IDEA ONE

West Side - Big Development

East Side - Big Scoop

IDEA FIVE

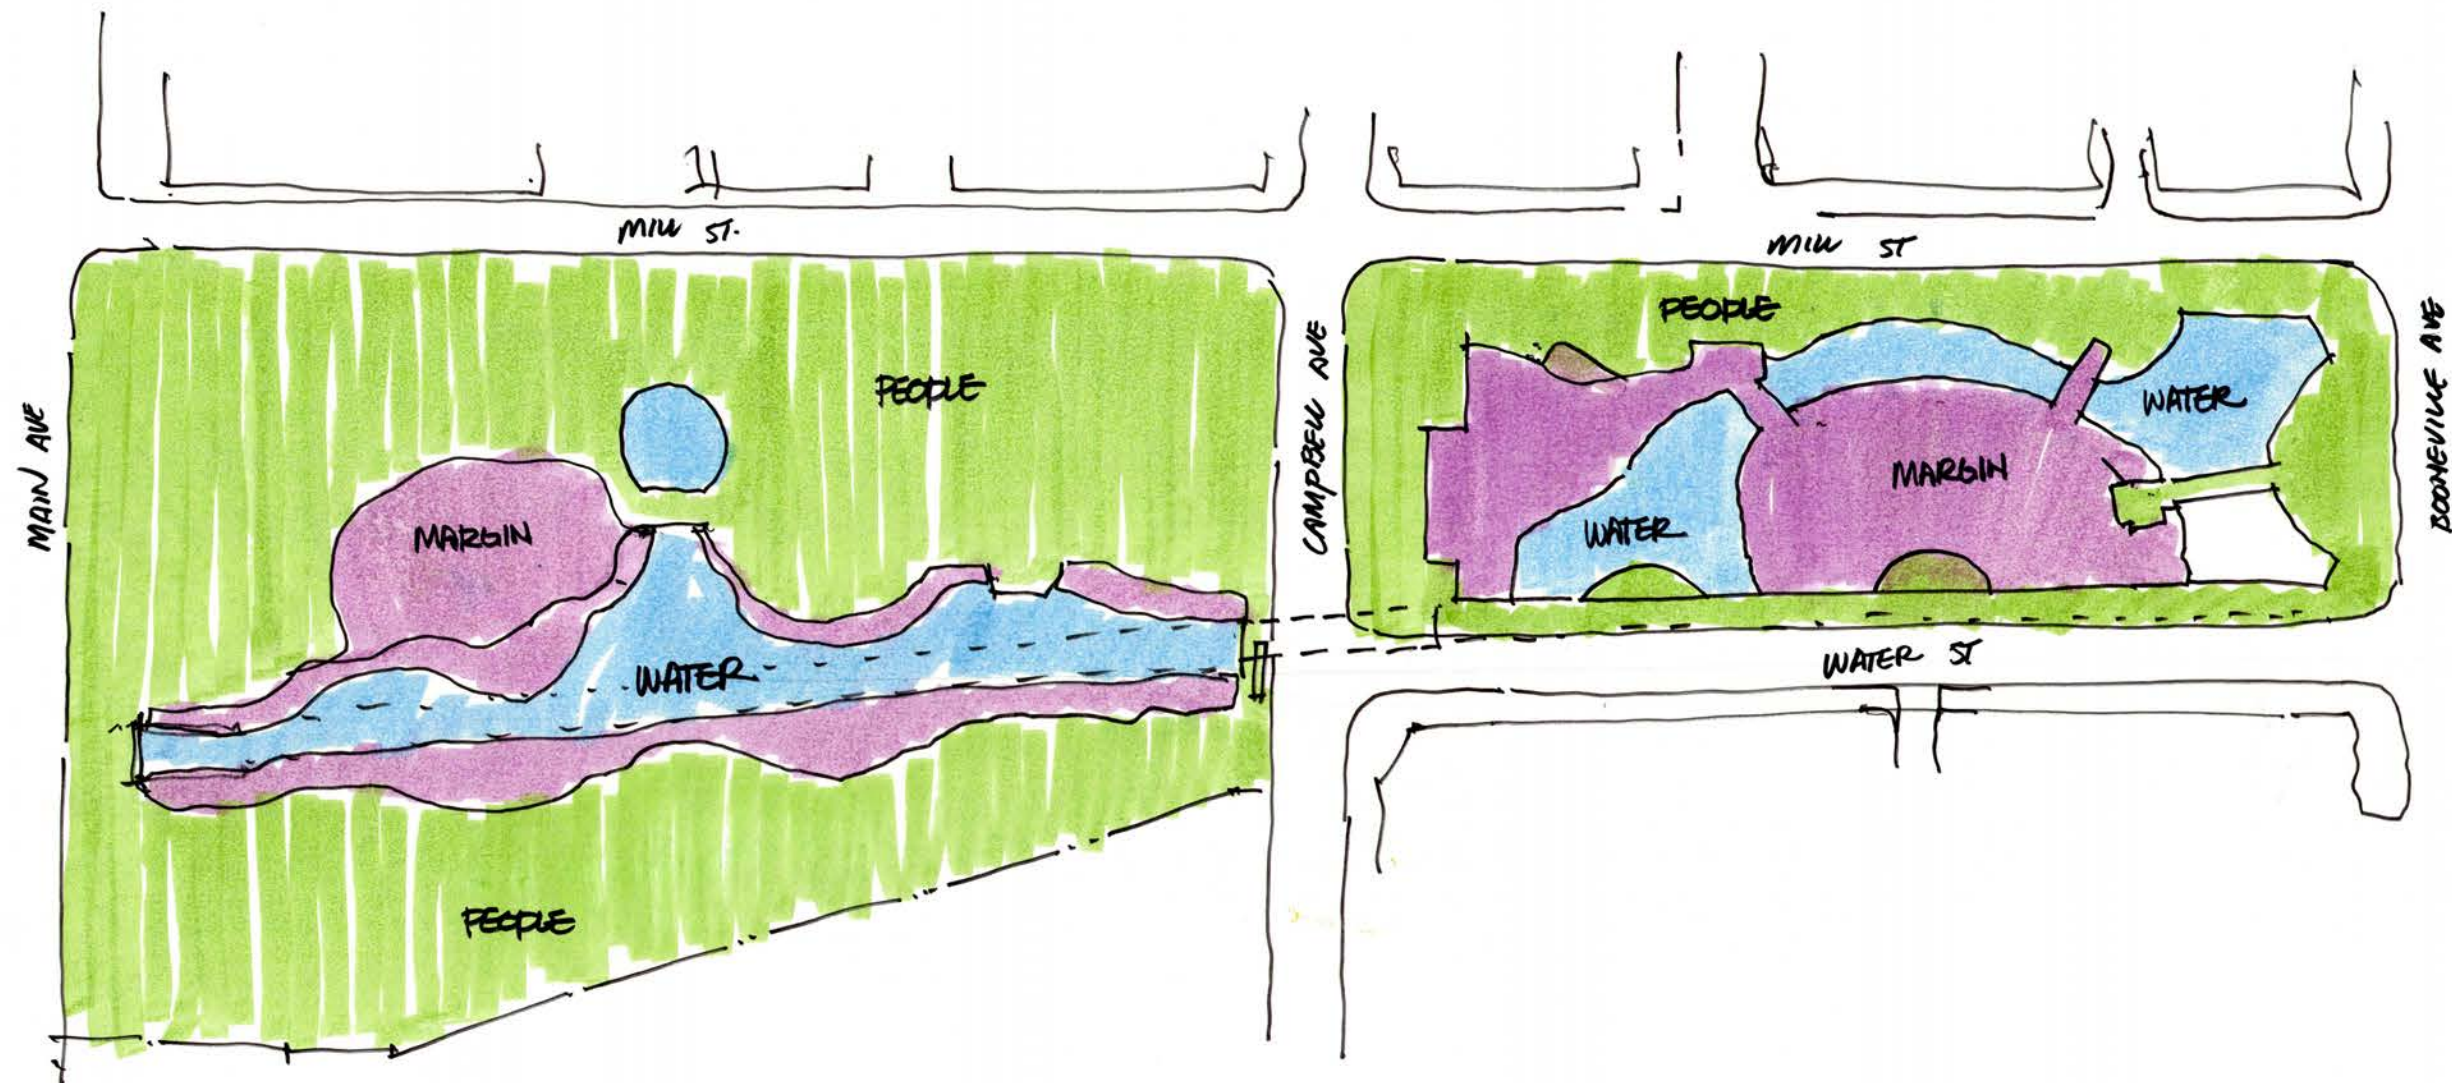
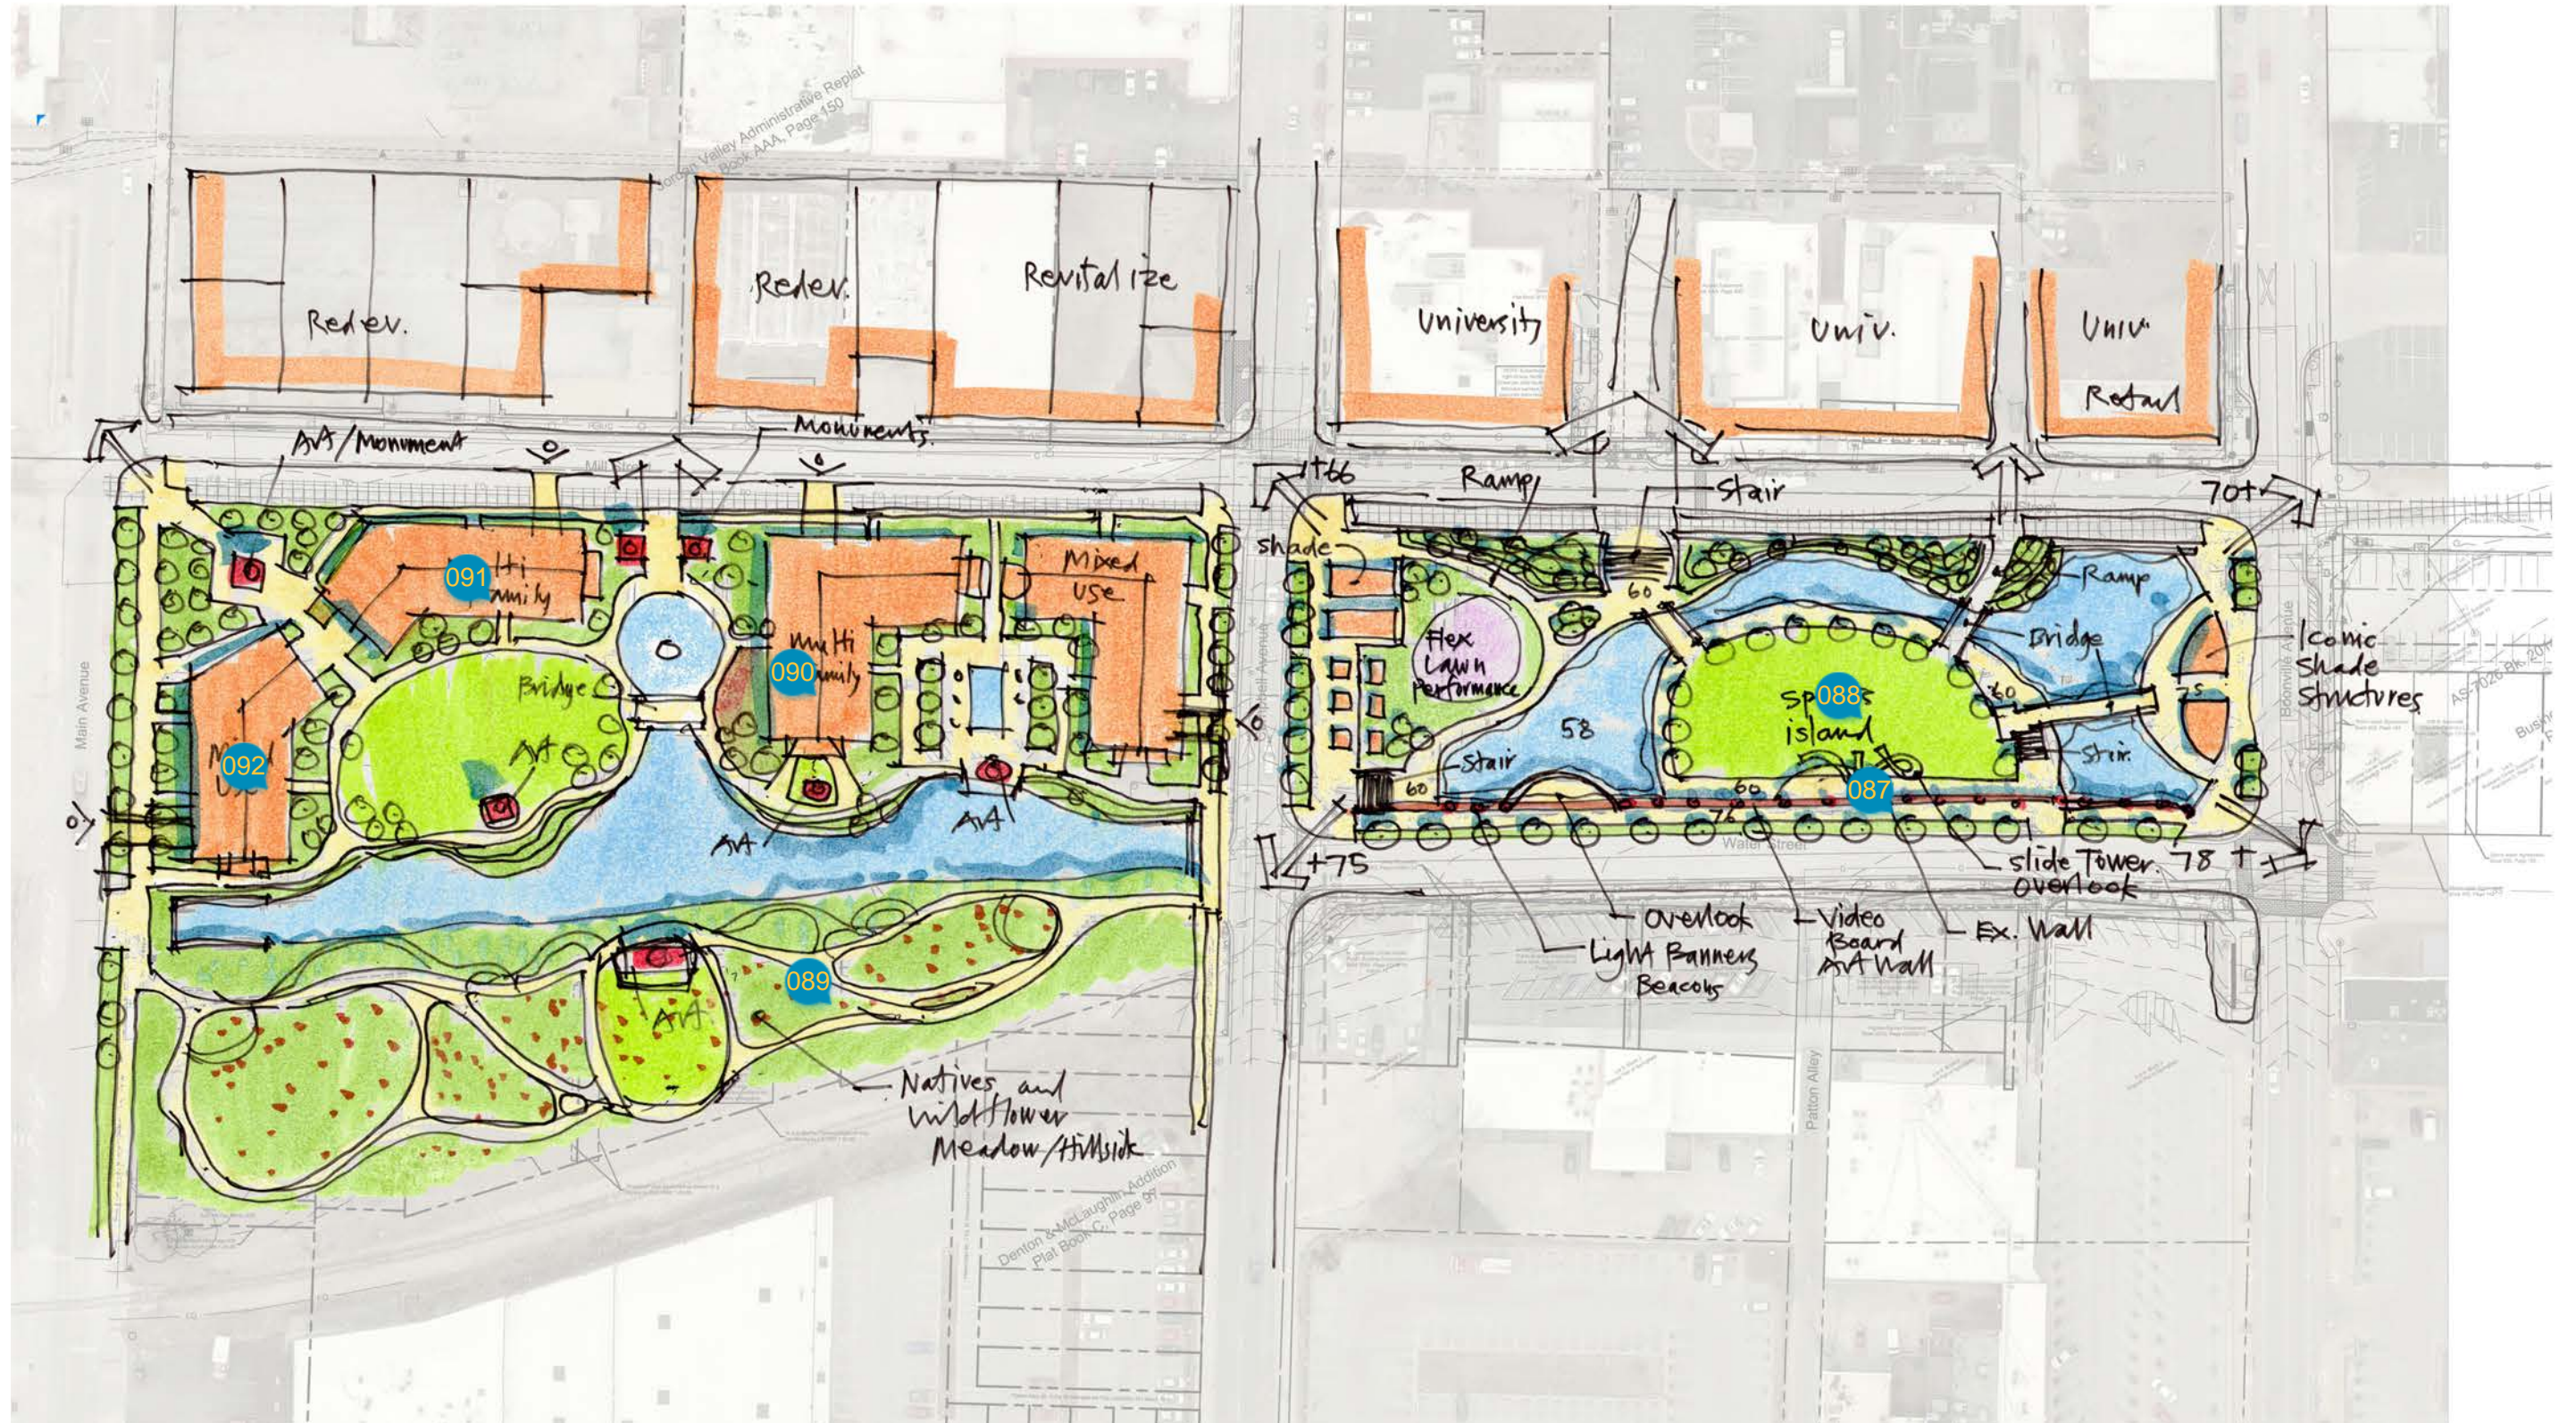
I like this idea of an "island" as a feature, but not sure if sports activities is the best way to engage the space.

I feel this is too much housing development in this small space, and it doesn't feel natural anymore. I would feel like I'm hanging out in an amenity that is intended only for those that lived here.

Too much development and multi-family not a good use of public space. This is a space for all - not tenants.

East Side - Box Hugger

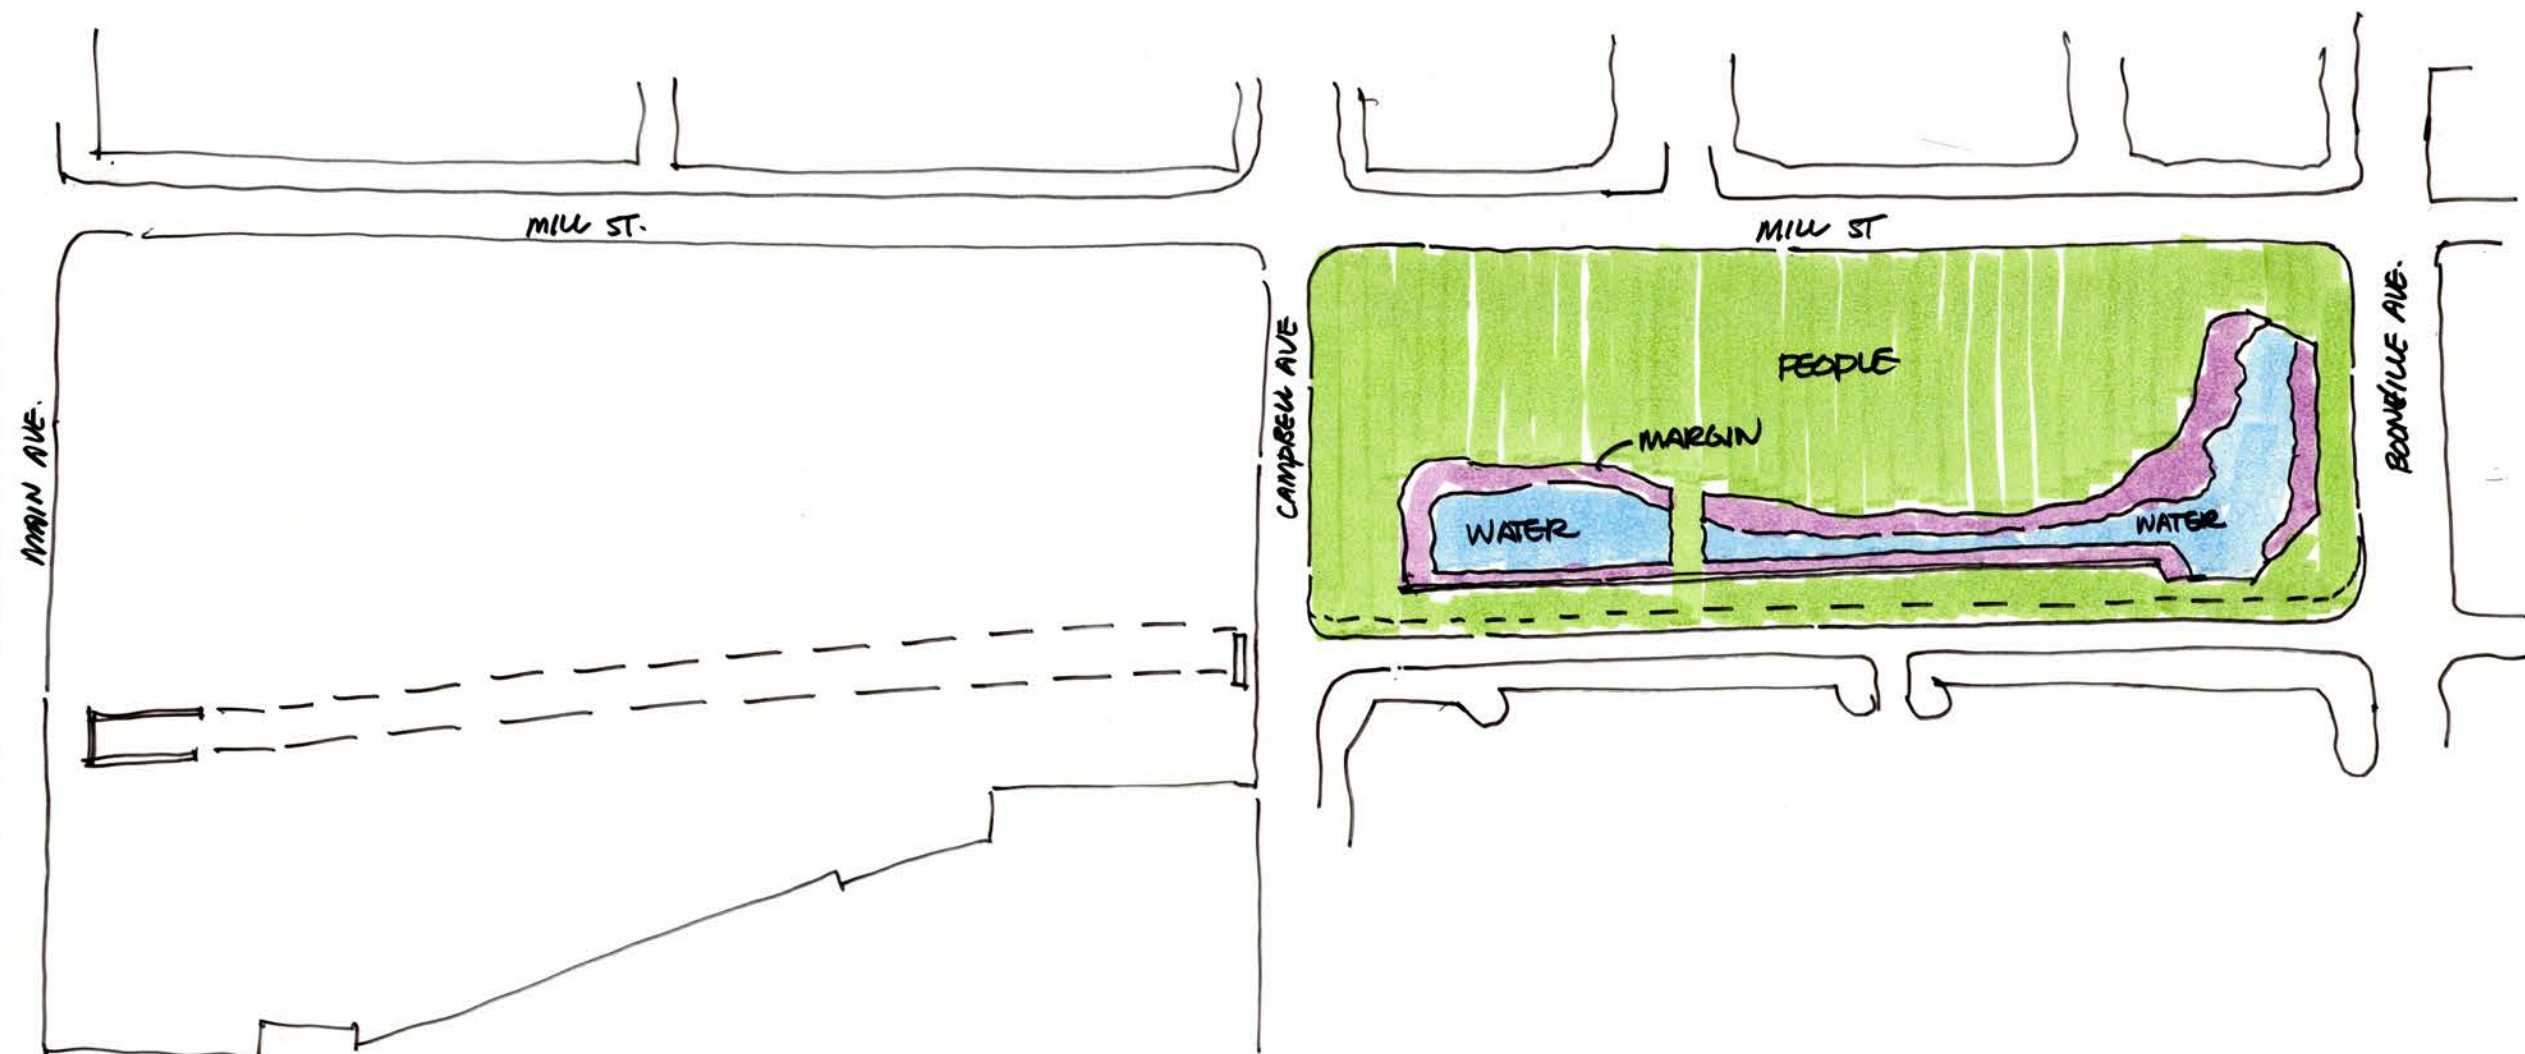
Way too much development.

Too me this one looks a little too much like a canal where we would be attempting to squeeze the water into a narrow deep corridor.
